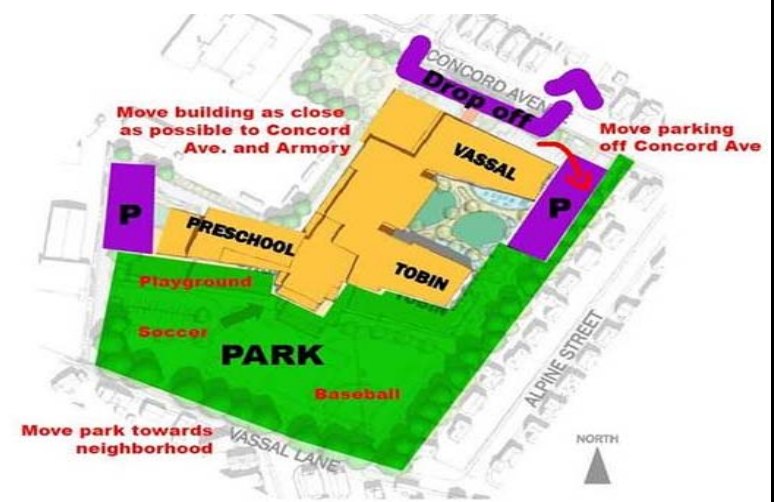
| Item | Date | Source | Comment | Response |
|------|------------|---------|---|---|
| P20 | 11/13/2019 | Post-it | Full size Soccer Field | The soccer field shown is sized for U-12 and under. |
